MATERIAL: SB-265 (UNS R56404)  
1 REQUIRED

DISCIPLINE ENGINEERING MANAGER	N/A	N/A																		
SAFETY CLASSIFICATION		DOCUMENT IDENTIFIER:		AS NOTED 000-M00-SSE0-02501-000																
DE CONCURRENCE	J. CLARK	JC	3/4/04	SIZE	SCALE	CAD FILE	REV	D NONE 000-M00-SSE0-02501-000.DRW 00B

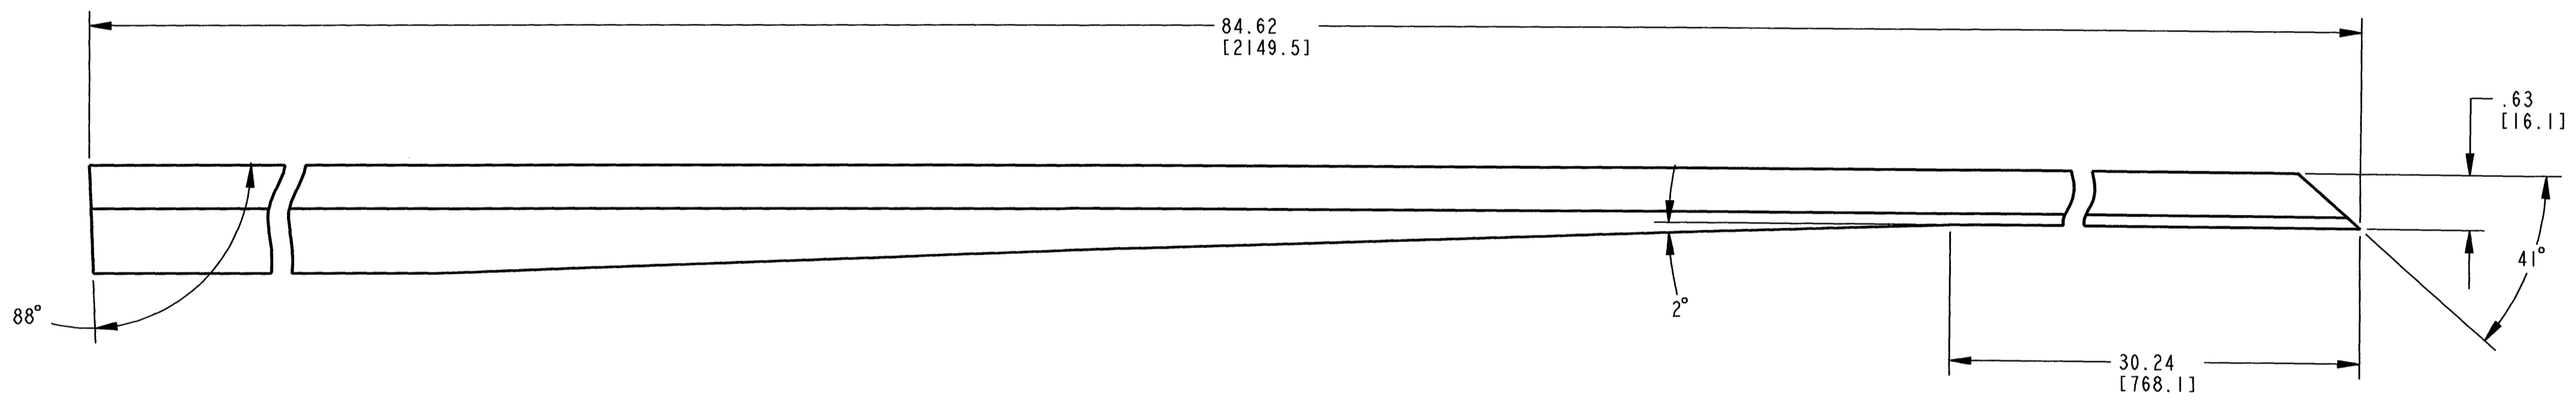
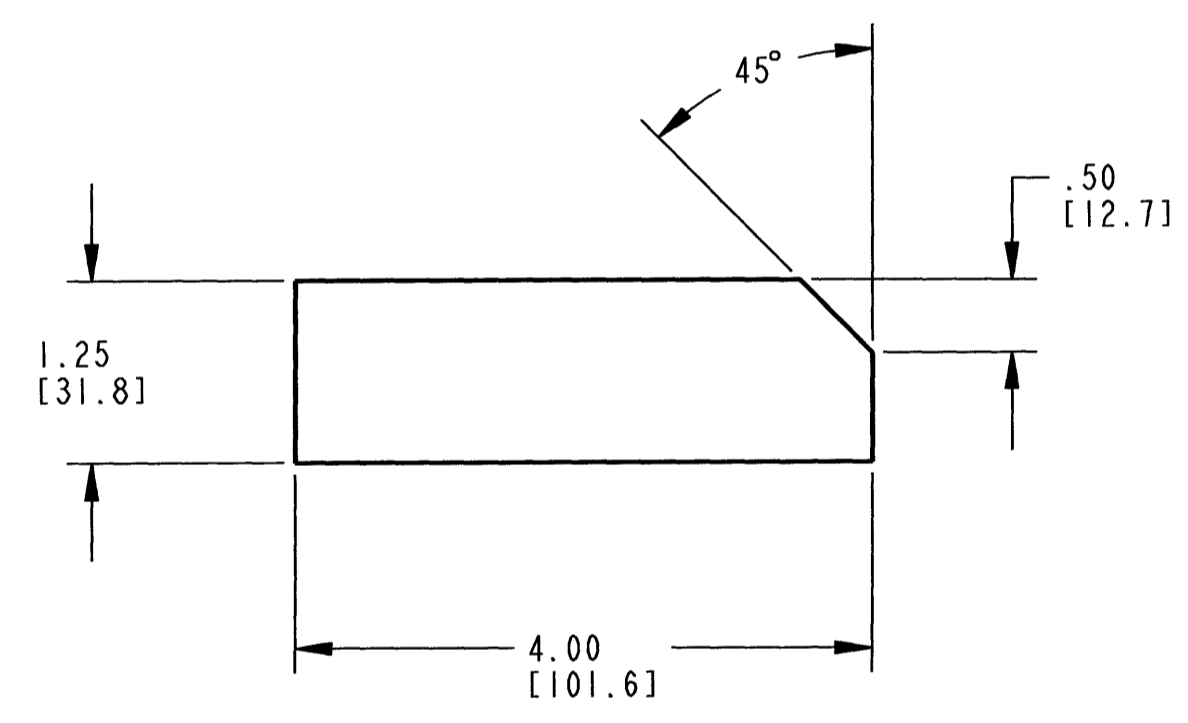
ODD	EXTENSIVE REVISION - CHANGED MATERIAL FROM SB-265 (UNS R56405) TO SB-265 (UNS R56404) PER TMRB-2006-004. REMOVED MATERIAL TO ELIMINATE INTERFERENCE WITH EXTERNAL SUPPORT PLATE. REVISED NOTE 4. ADDED DESIGN INPUT REFERENCE LIST. ADDED REFERENCE DRAWINGS.	4/23/07																		
ODA	INITIAL ISSUE	3/4/04	ZC	AS	AS	CC	N/A	JC												
REV	DESCRIPTION	DATE	ENG	CHE	EGS	FE	DEM	QE												
REVISION HISTORY																				
APPROVALS		INITIAL/DATE		<b>U.S. DEPARTMENT OF ENERGY</b> <b>Office of Civilian Radioactive Waste Management</b> <b>BECHTEL</b> Management and Operation of the Office of <b>SAIC</b> Civilian Radioactive Waste Management Program																
ORIGINATOR	Z. CETLAN	ZC	3/4/04	<b>DRIP SHIELD CONNECTOR</b> <b>LEFT SUPPORT BEAM</b>																
CHECKER	A. SCHEIDER	AS	3/4/04																	
ENGINEERING GROUP SUPERVISOR	A. SCHEIDER	AS	3/4/04																	
PROJECT ENGINEER	C. CHAGNON	CC	3/4/04
